**PLANNING REF 25/00840/OUTM, LAND ADJACENT ROMANS FARM CHASE AND MILL ROAD BURNHAM-ON-CROUCH ESSEX**

I strongly object to this application because it conflicts with the Maldon Local Development Plan (MLDP), the Made Burnham-on-Crouch Neighbourhood Plan (BNP), the National Planning Policy Framework 2024 (NPPF), Manual for Streets 2 (MfS2), the Equality Act 2010 and other material guidance.

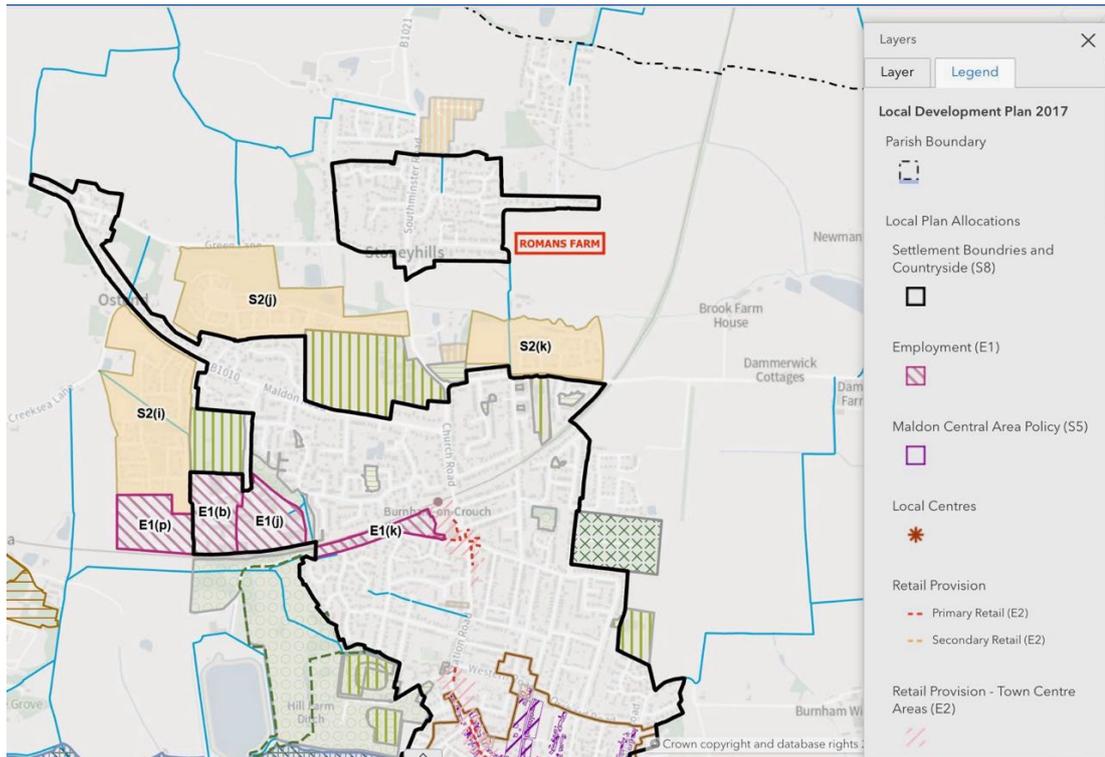
1. **ROMANS FARM IS OUTSIDE SETTLEMENT BOUNDARIES AND IS NOT IN A STRATEGIC GROWTH AREA OR A GARDEN SUBURB**
- 1.1. The site is outside the settlement boundaries for Burnham and Stoneyhills as set out in the MLDP. The image below (Figure 4 on page 14 of the Made BNP and the policy map in the MLDP for the South East Area of the District) shows the Employment and Housing Area Allocations from the MLDP. The application site at Romans Farm is named in red on the image and it clearly shows that this site lies outside the settlement boundaries, which are shown by the black boundary lines.

- 1.3. Policy S2 of the MLDP says that strategic growth in Burnham-on-Crouch will be confined to three strategic growth areas, which are shown in the image in paragraph 1.1. On page 17 of the MLDP it says:

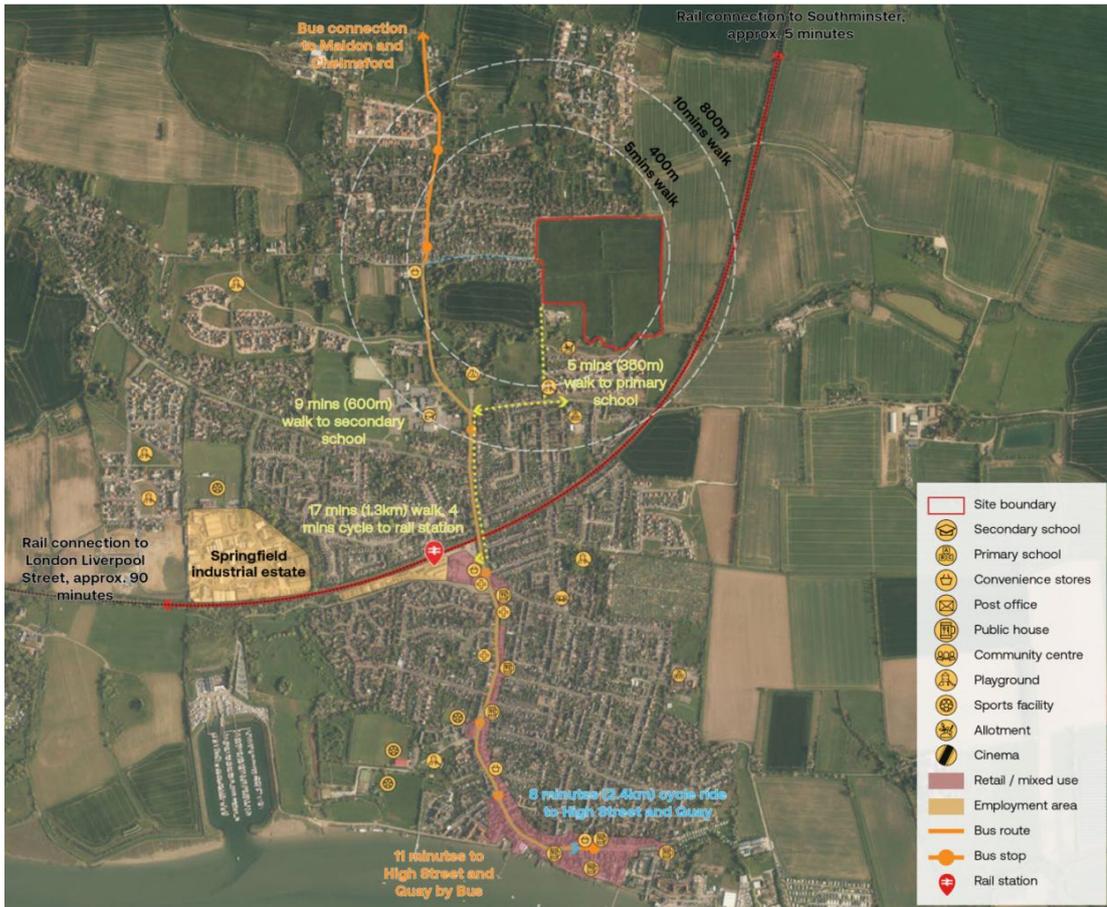
3.5. This section was accompanied by a graphic to show various things, including walking time. The graphic is shown below:

- 3.6. The 400m (and, therefore, the 800m too) walking time and distance is in error. Section 4 below provides information about widths of Mill Road and distances to the bus stop at Eves Corner from various points along Mill Road. Those points are labelled A, B and C on the first image and A, B, C and D on the second image. Those points are shown in purple and the distances from the bus stop to each of them are shown on the tables on each image. All the measures were taken using a measuring wheel and verified using Google Earth. They are, therefore, real life walking distances.

- 3.7. The Welbeck Land image at paragraph 3.5 shows that the 400m walking distance (or 5 minute walking time) is from the North East corner of the site. The real-life distance using Mill Road to the same point is just over 1km. As that 400m walking distance and time is in error, it can be concluded that the 800m distance is also in error. This also calls into doubt the accuracy of the other distances and walking times illustrated on the consultation website. The responses to the consultation were, therefore, based on more favourable information than is the situation in fact and was clearly misleading and in error.

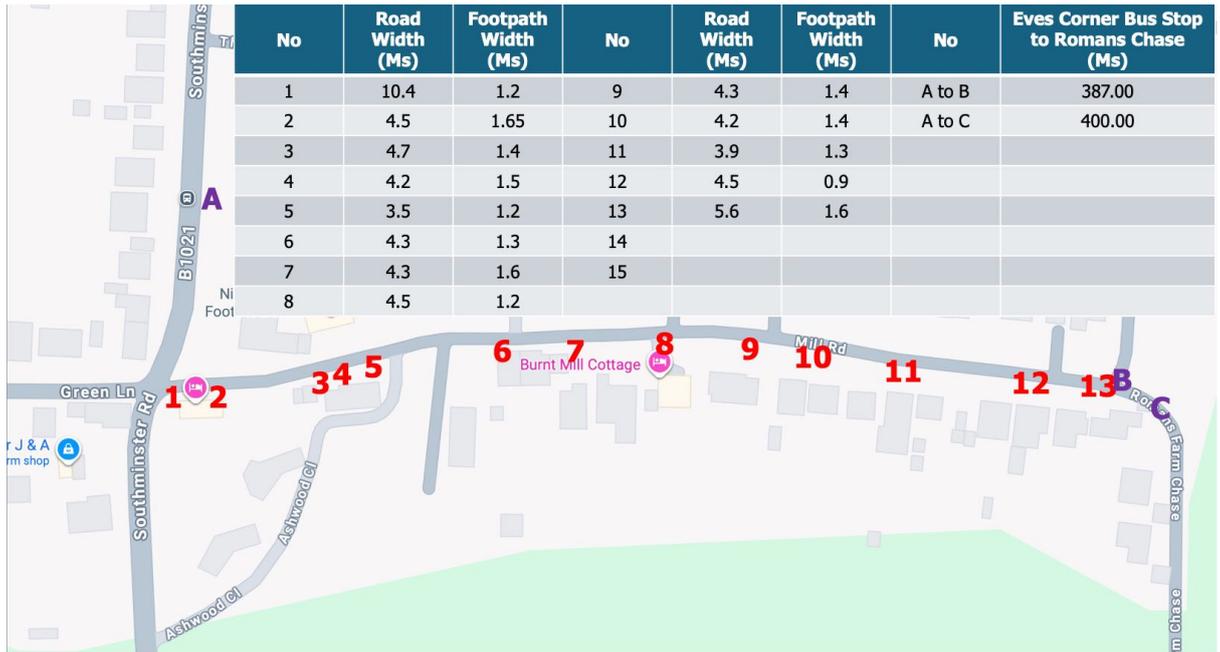
4.2. Mill Road was not built to service that amount of traffic. It is an unclassified road which does not meet the standard width (5.5m) for a road in a new development of this size (Essex Design Guide, table of Street Types). At its widest on the part of Mill Road that leads to the junction with Romans Farm Chase from the junction with Southminster Road it is 4.7ms wide and narrows to 3.5ms within a few metres. There are only two points after this choke point when the road reaches 4.5ms wide. Visibility along Mill Road is impeded by the width, narrowing and shape of the road. To put this in perspective a 7.5 tonne lorry can only be 2.55m wide. Two lorries cannot pass each other safely along Mill Road without mounting the only pavement on the road. This can only risk highway safety and raise the level of risk of conflict between pedestrians, cyclists and vehicles substantially.

4.3. The footway was also measured at each of those points. The measures confirm that the road and the footway are both too narrow at most points along the length of Mill Road. The images below show the widths of both the road and the footway at 24 points along the length of Mill Road (location indicated by the red numbers) from the junction with Southminster Road. The tables on each image show the relevant measures against each number:
